SUBJECT: Responds to conclusions stated in NRC safety evaluation re
 C-E guidelines for steam generator tube rupture & loss of
 main feedwater. Revision to C-E emergency procedure
 guidelines will incorporate response.

Subject: C-E Generic Emergency Procedure Guidelines

In support of your current review of the Emergency Operating Instructions for San Onofre Nuclear Generating Station, Units 2 and 3, two enclosures are provided. The contents of these enclosures respond to requests stated in the NRC letter to the C-E Owners Group dated March 6, 1981 and are consistent with discussions between members of your staff, Southern California Edison, and Combustion Engineering at a meeting on April 10, 1981.

Figure 2
SATURATION

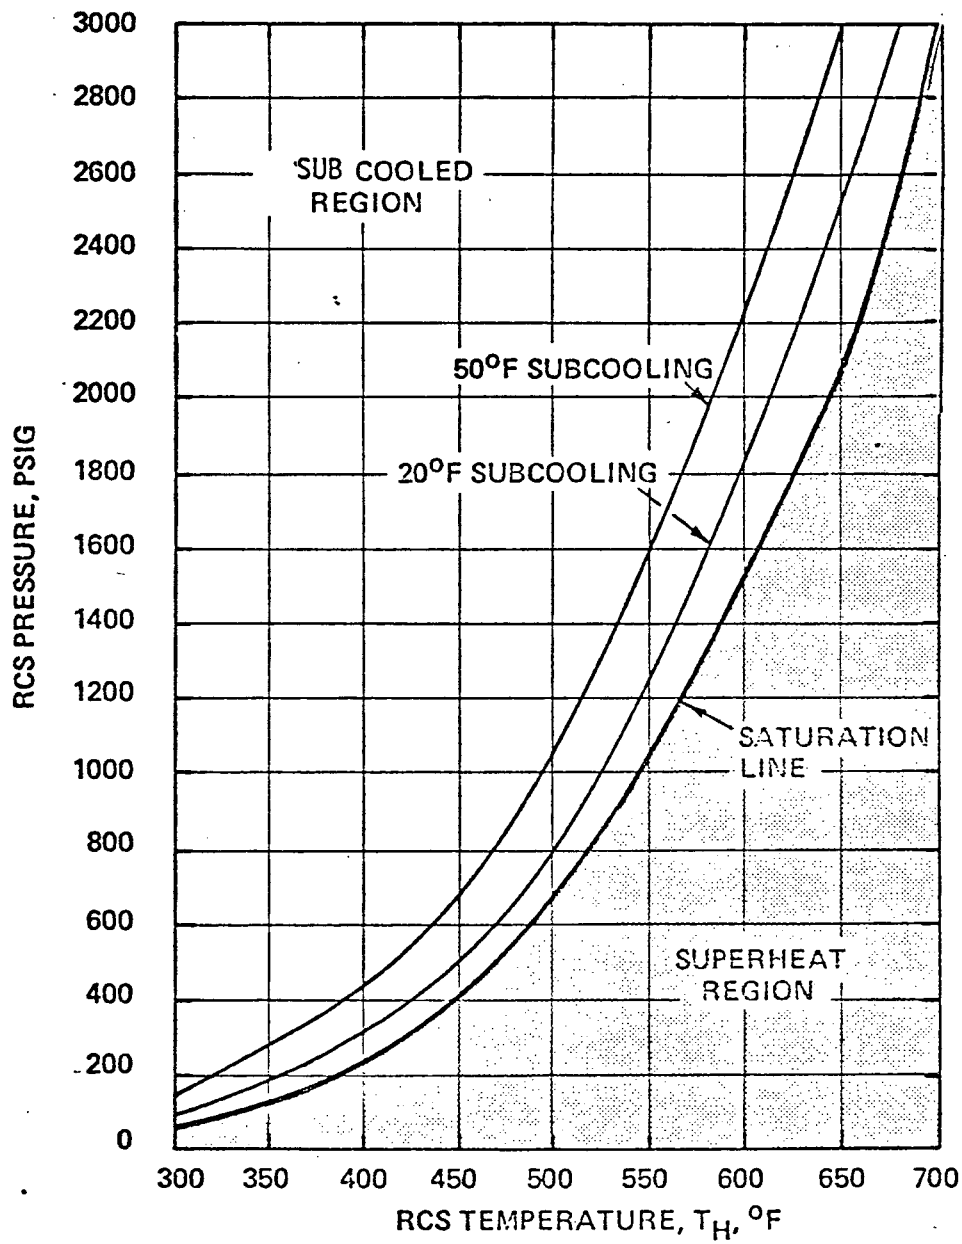
1. A review by C-E must be completed on the use of a smaller sub-cooling margin criteria for HPI termination. Inclusion of a pressurizer level indication in conjunction with a subcooling margin should be incorporated in the HPI termination criteria sections of the guideline unless justification for its exclusion can be made.

The requirement that a $20^{\circ}\text{F} + [\text{inaccuracies}]$ subcooled margin exists at safety injection termination is included in the SGTR Guideline. In addition, the guideline states that if this subcooling margin cannot be maintained, the Safety Injection System must be restarted. See below.

- ✓ After an SIAS operate the [SIS] until:
- a) RCS hot and cold leg temperatures are at least $20^{\circ}\text{F} + [\text{inaccuracies}]$ below saturation temperature for pressurizer pressure (refer to Figure 2),
 - b) a pressurizer level is indicated,
 - c) one steam generator has an indicated level and is removing heat from the RCS.

✓ If $20^{\circ}\text{F} + [\text{inaccuracies}]$ of subcooling cannot be maintained after the SIS has been stopped, the HPSIS must be restarted.

Figure 2
SATURATION

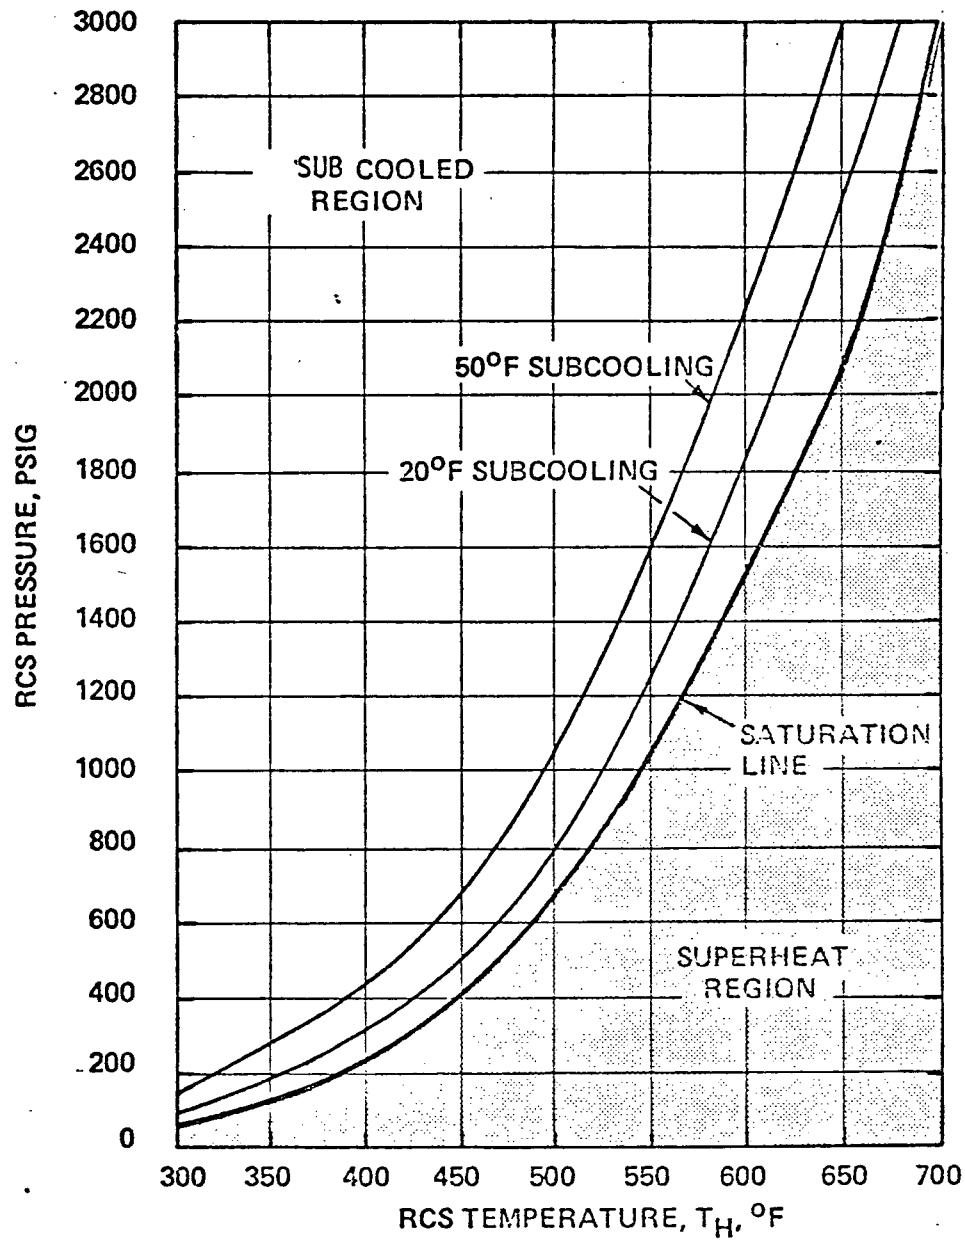
1. A review by C-E must be completed on the use of a smaller sub-cooling margin criteria for HPI termination. Inclusion of a pressurizer level indication in conjunction with a subcooling margin should be incorporated in the HPI termination criteria sections of the guideline unless justification for its exclusion can be made.

The requirement that a $20^{\circ}\text{F} + [\text{inaccuracies}]$ subcooled margin exists at safety injection termination is included in the SGTR Guideline. In addition, the guideline states that if this subcooling margin cannot be maintained, the Safety Injection System must be restarted. See below.

- a) RCS hot and cold leg temperatures are at least $20^{\circ}\text{F} + [\text{inaccuracies}]$ below saturation temperature for pressurizer pressure (refer to Figure 2),
- b) a pressurizer level is indicated,
- c) one steam generator has an indicated level and is removing heat from the RCS.

✓ If $20^{\circ}\text{F} + [\text{inaccuracies}]$ of subcooling cannot be maintained after the SIS has been stopped, the HPSIS must be restarted.
